## **CONSTRUCTION CHANGE ORDER NUMBER 01**

**PROJECT:** St Pete-Clearwater International Airport  
Airport Landside and Parking Lot Improvements - Rebid  
(PID Number: 001546A)

**CONTRACT NO:** 167-0509-CP(PF)

This Change Order is for various items related to revisions to the plans and associated time extensions.

**Maintenance of Traffic Plans**

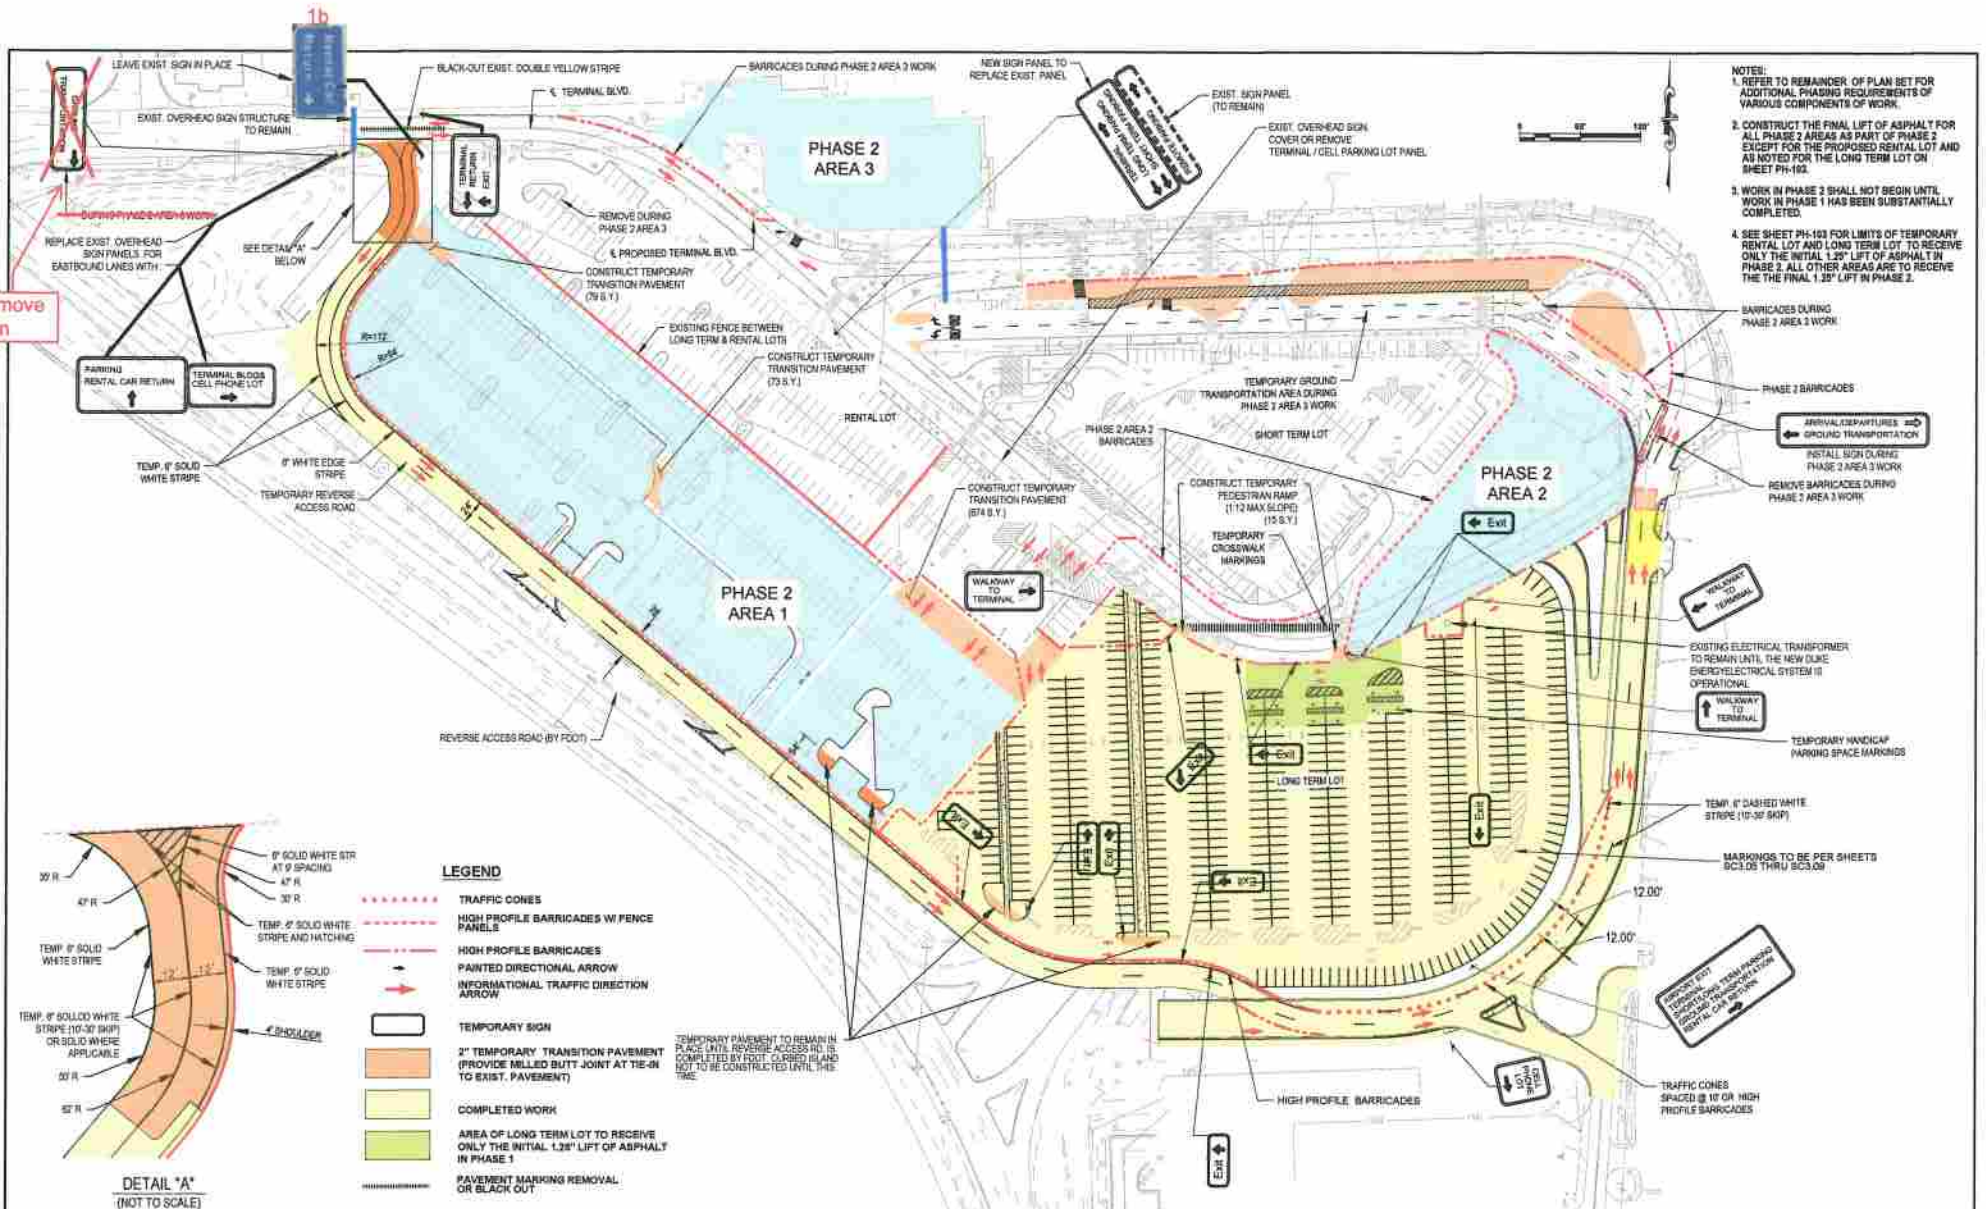
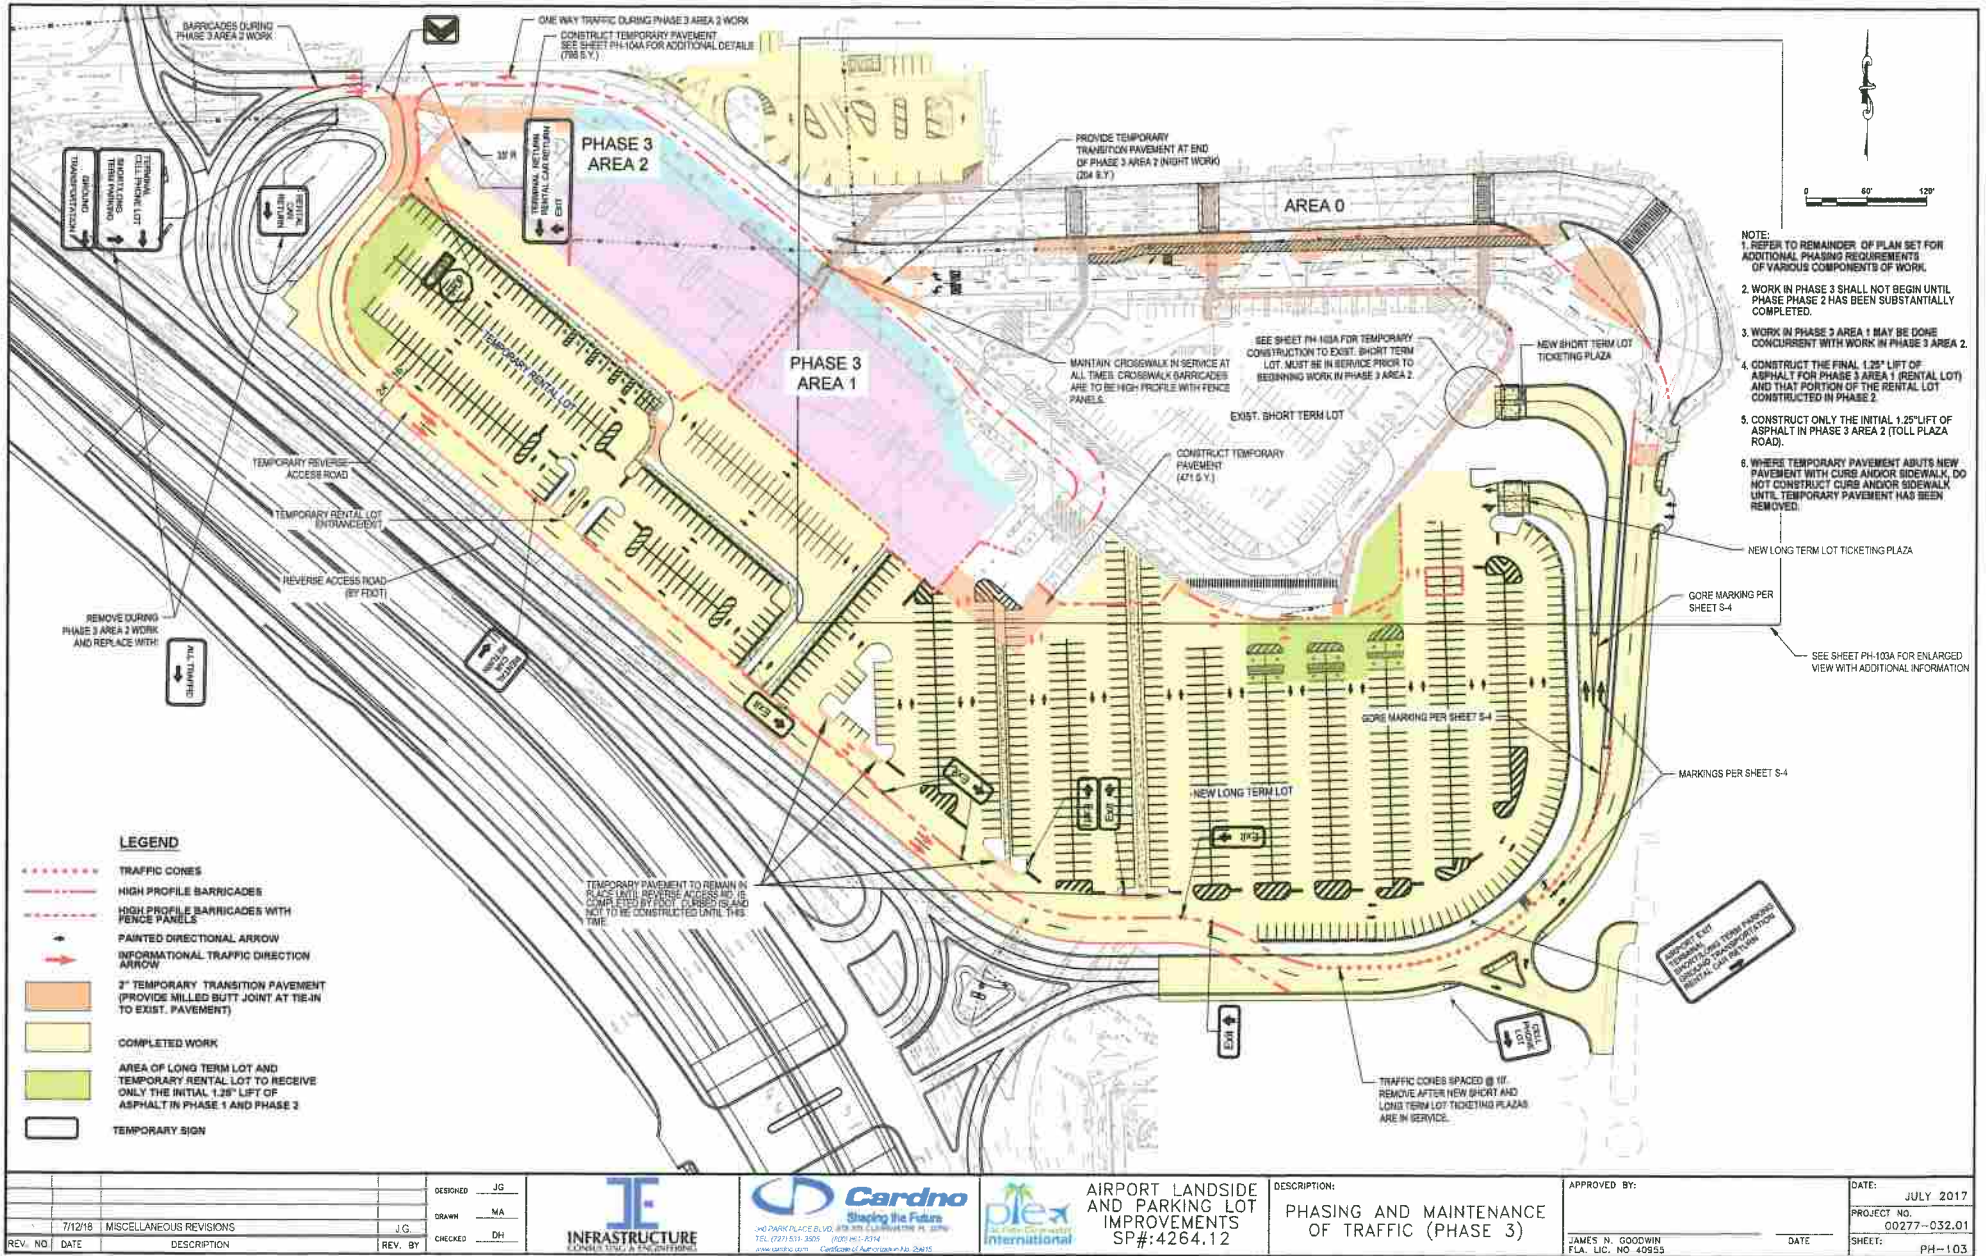
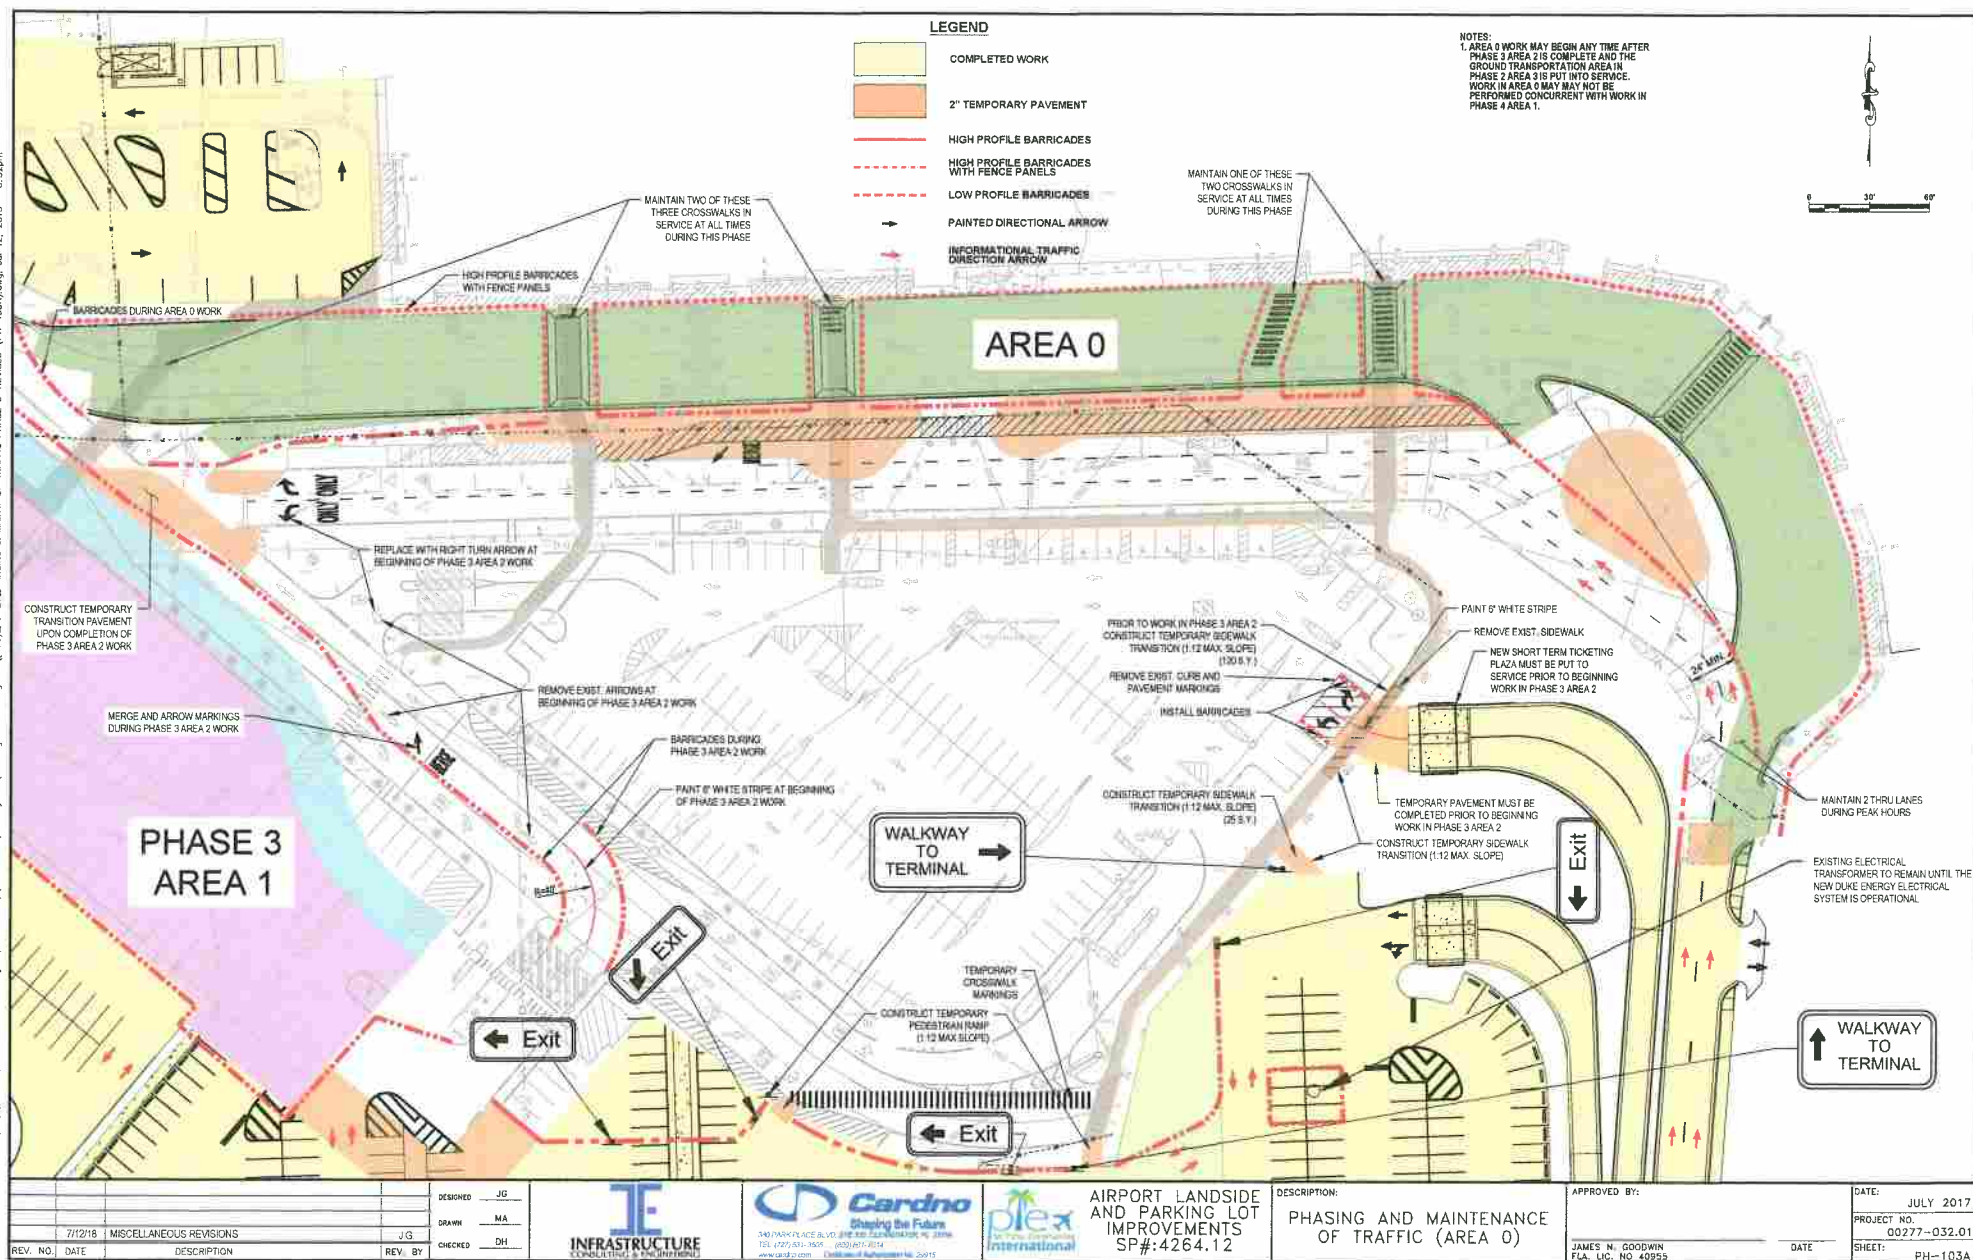
The Owner and the Contractor have mutually agreed that a re-phasing of the project is acceptable to reduce operational impacts to the Airport. (Attachment "A" contains the most recent Maintenance of Traffic (MOT) plans showing the re-phasing of this project). The County and the Contractor have negotiated and mutually agreed to a lump sum cost of three hundred and nineteen thousand three hundred dollars and zero cents (\$319,300.00) to be made in partial payments on a prorated basis as work is completed under a new line item Maintenance of Traffic – Re-Phasing.

An additional one hundred and forty nine (149) calendar days will be also be added to the duration of the project for the Contractor to reach Final Completion.
